METROPOLITAN GOVERNMENT OF NASHVILLE AND DAVIDSON COUNTY

STAFF RECOMMENDATION
1720 4th Avenue North
March 19, 2014

Application: Demolition; New construction-infill and outbuildings; Setback determination.

Description of Project: Application is to demolish a non-contributing structure and to construct a duplex and two detached garages. The garages require a setback determination. Base zoning requires that the garages be placed twenty feet (20') from the rear property line, but the applicant is proposing to locate the garages ten feet (10') from the rear property line.

Figure 1. 1720 4th Avenue North

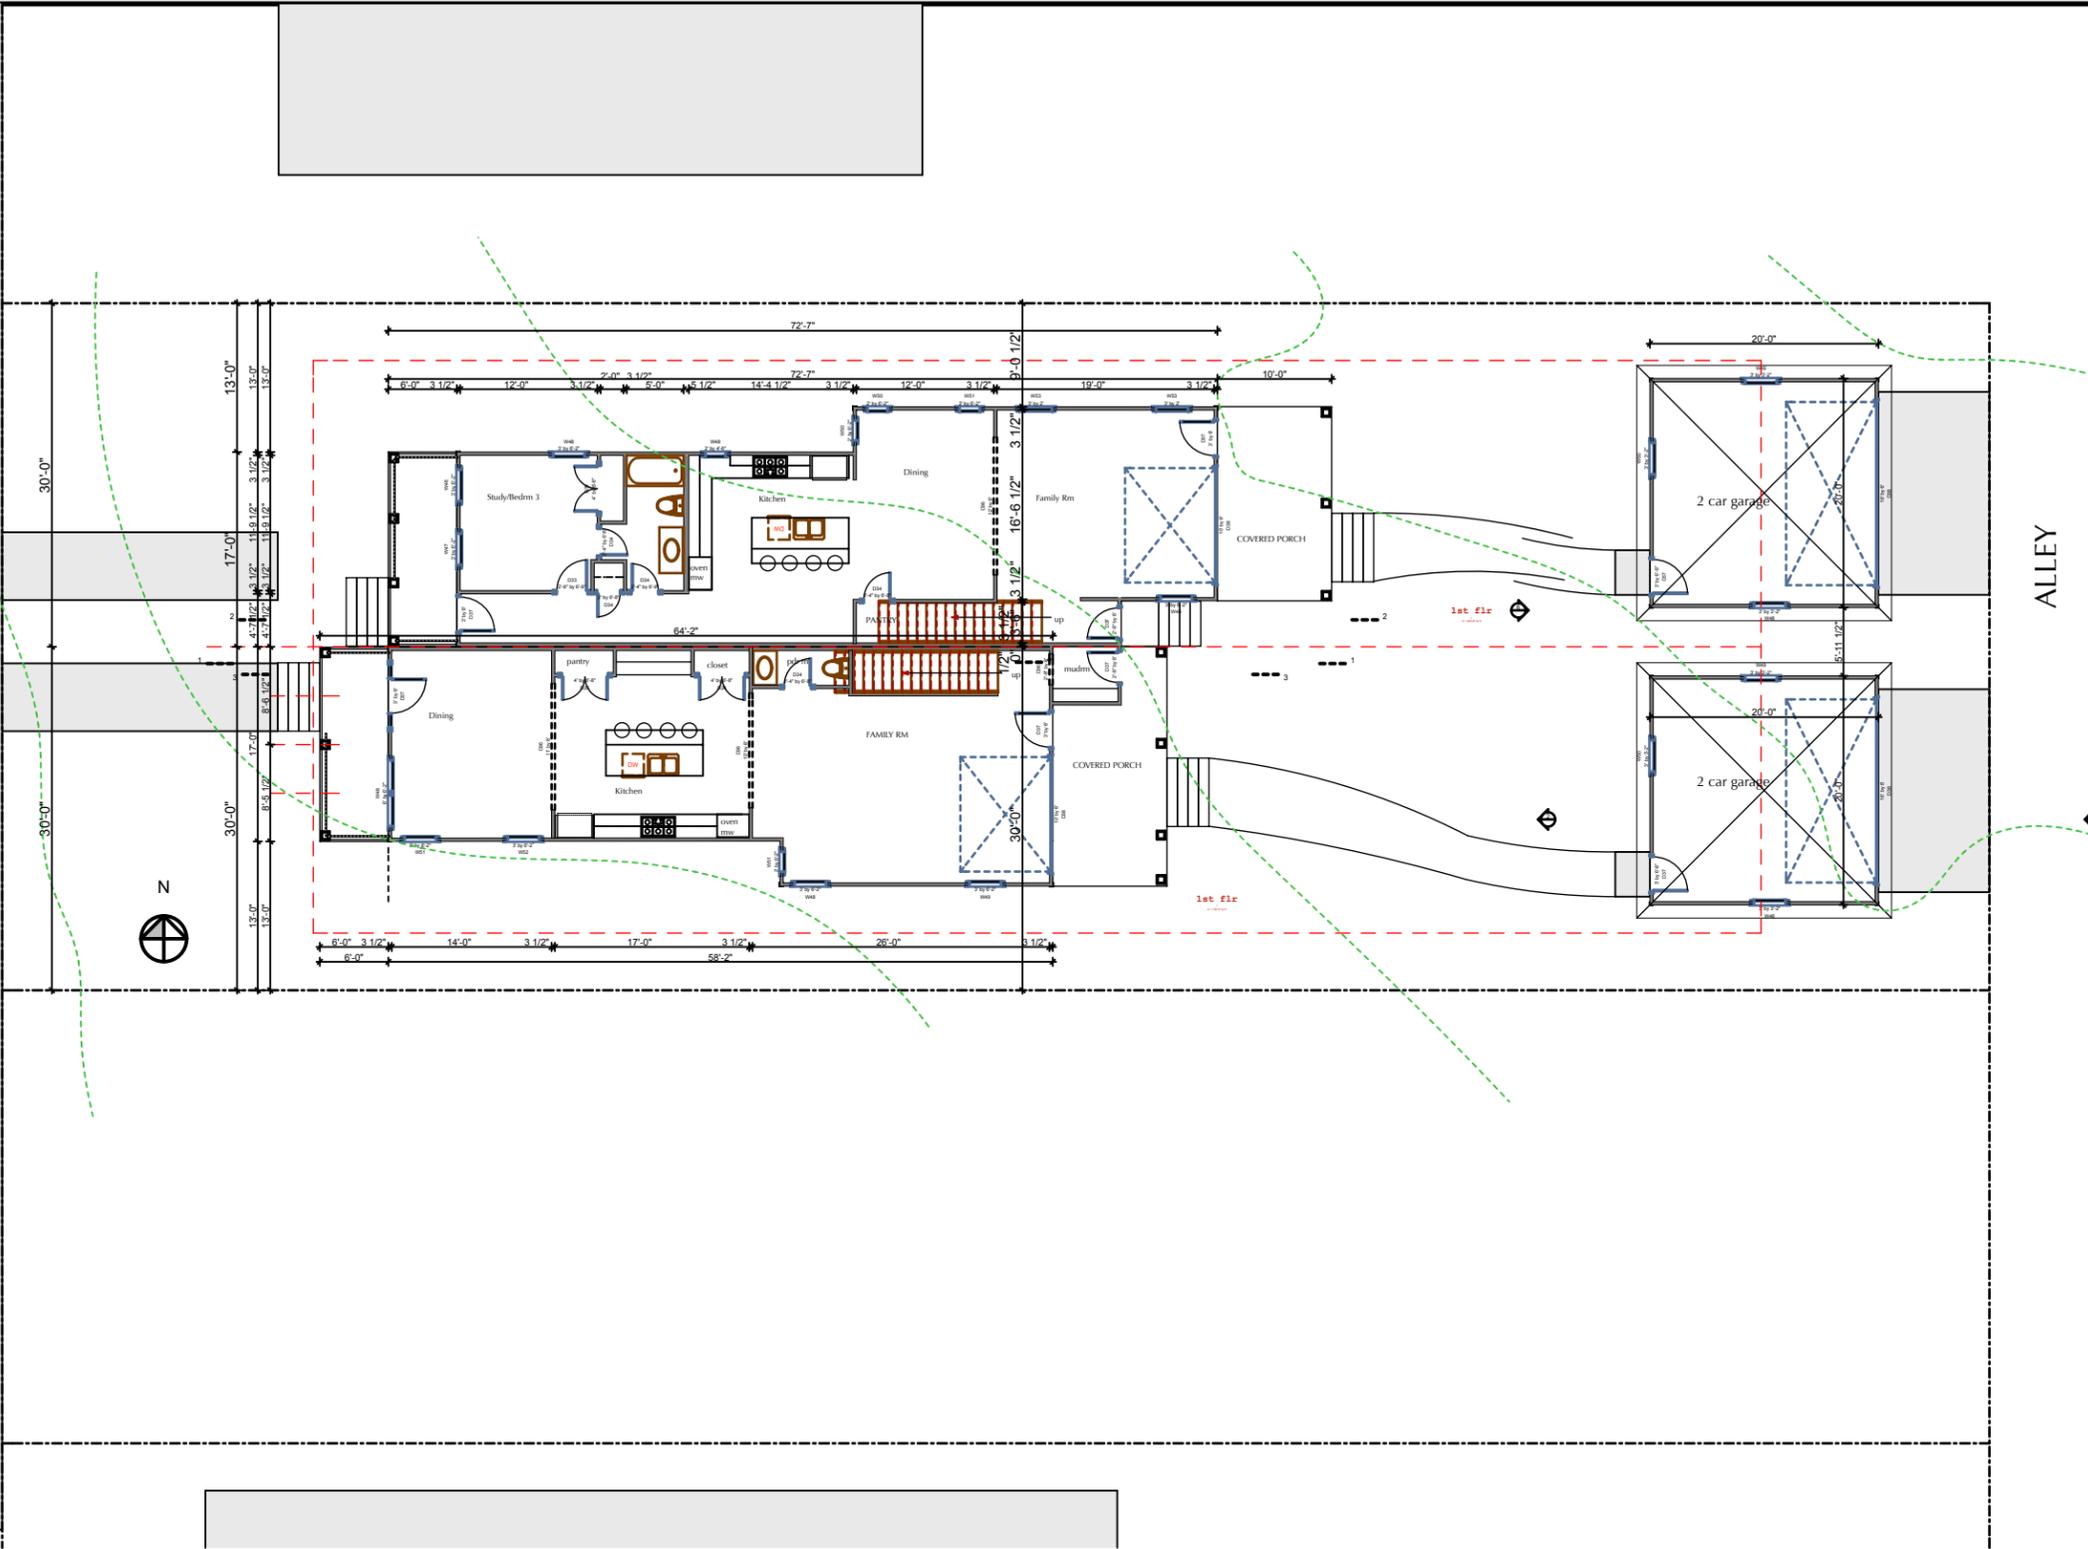
Background: 1720 4th Avenue North is a non-contributing house constructed c. 1988 (Figure 1).

Demolition: The existing house at 1720 4th Avenue North was constructed c. 1988, much later than the period of significance for the Salemtown Neighborhood Conservation Zoning Overlay. The building's materials, form, and style are not in keeping with the historic Salemtown neighborhood, and it does not contribute to the historical and architectural character and significance of the district. Staff therefore finds that the demolition of the structure meets section V.B.2 for appropriate demolition and does not meet section V.B.1 for inappropriate demolition.

SITE PLAN

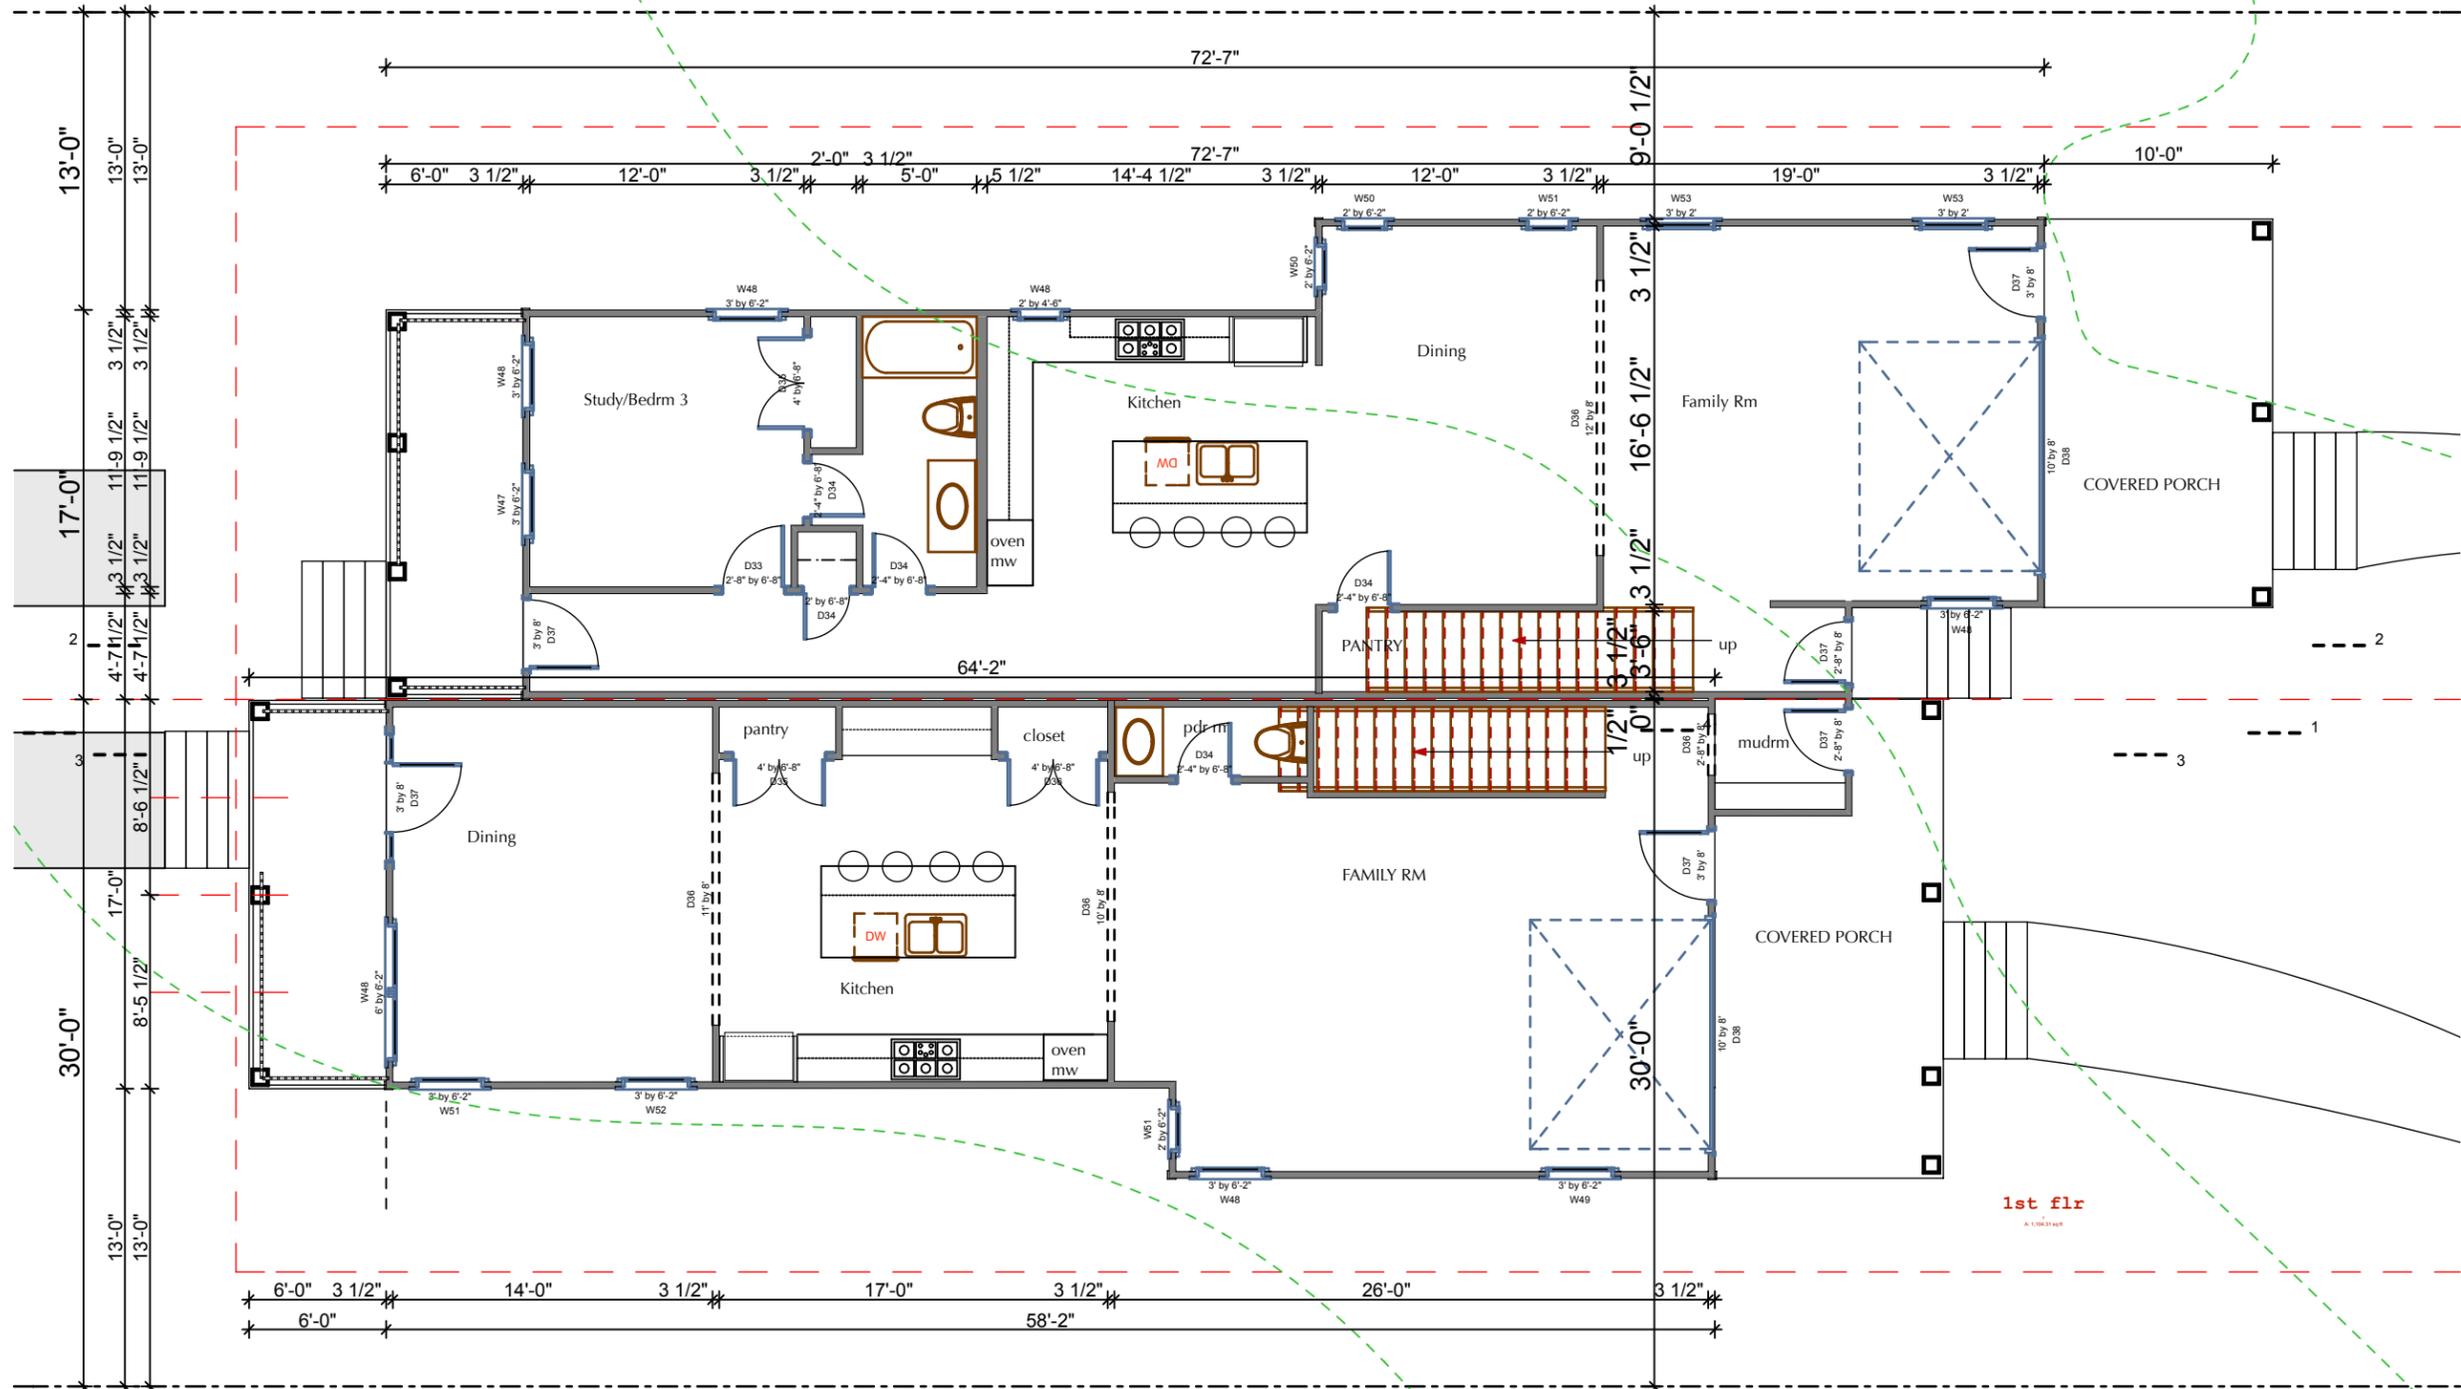
Setback & Rhythm of Spacing: The duplex's lot is sixty feet (60') wide, which is wider than a typical lot in area. The duplex will be centered on the lot, and meets all base zoning requirements for setbacks. It is a minimum of nine feet (9') from each of the side property lines, and over fifty-seven feet (57') from the rear property line. The porch of the projecting right unit will be set back approximately twenty-eight feet (28') from the front property line. By comparison, the one-story, non-contributing house to the right of the site is set twenty-four feet (24') from the front property line. To the left of the site is a vacant lot, and the one-story shotgun house to the right of the vacant lot is approximately eighteen feet (18') from the front property line. Because the new duplex will be two-stories and significantly taller than the non-contributing structure to its left and the historic shotgun to its right, staff finds that the front setback, which is pushed back slightly than its neighbors, is appropriate. Staff finds that the duplex's setback and rhythm of spacing meets section II.B.1.c. of the design guidelines.

Outbuildings: The application includes two, twenty foot by twenty foot (20'x20') garages. The garages will be one story, with an eave height of nine feet (9') and a ridge height of fifteen feet, four inches (15'4"). The garages will be located in the rear of the property, and will be accessed via the alley, with garage doors facing the alley. Because when considered together, the square footage of the two garages is more than seven hundred square feet (700 sq. ft.), the base zoning setbacks for the garages are set at five feet (5') from the side property lines and twenty feet (20') from the alley. The garages meet the side setbacks, as they will be a minimum of six feet (6') from the side property lines. However, the garages require a setback determination for the rear because they are proposed to be located ten feet (10') from the alley. Staff finds the proposed rear setback of ten feet (10') rather than twenty feet (20') to be appropriate because historically, outbuildings were located close to the alley.

GARAGES

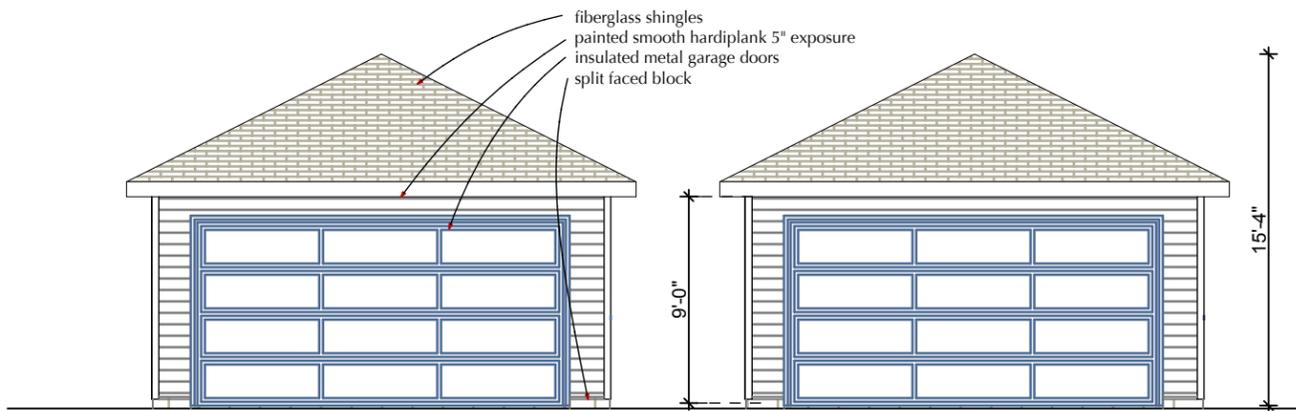
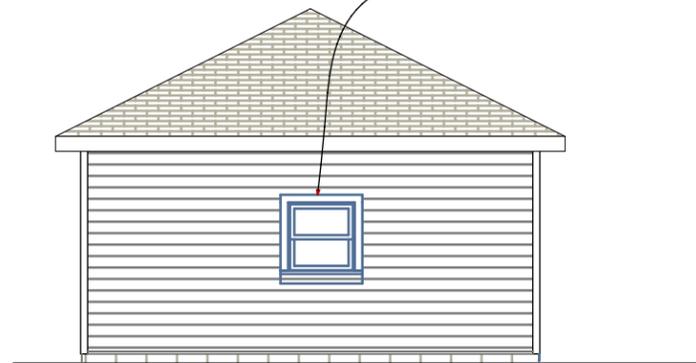
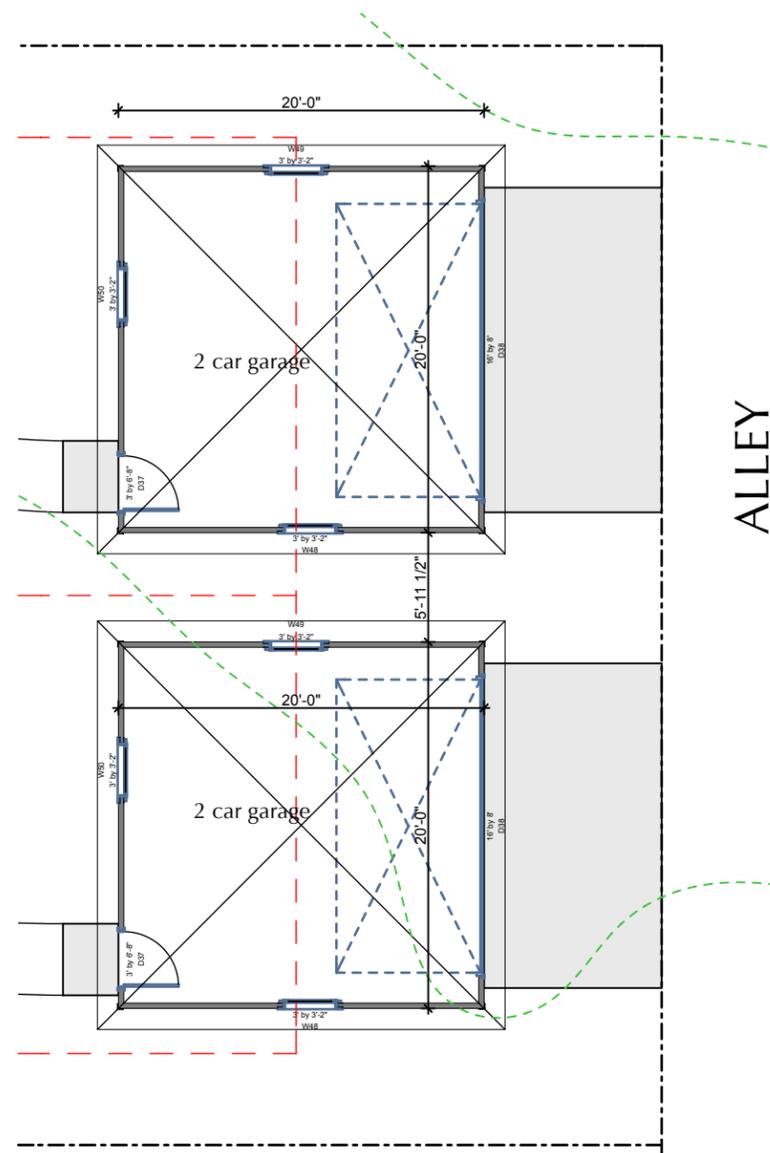
The materials for the garages will be a split face block foundation, smooth face cement fiberboard with a five inch (5") reveal, fiberglass shingles, metal vehicular door, and wood windows. The roofs will be hipped with a 6/12 slope. The window and door openings on the garages are appropriate for outbuildings. Staff finds that the proposed garages and their setback determination meet section II.B.1.h of the design guidelines.
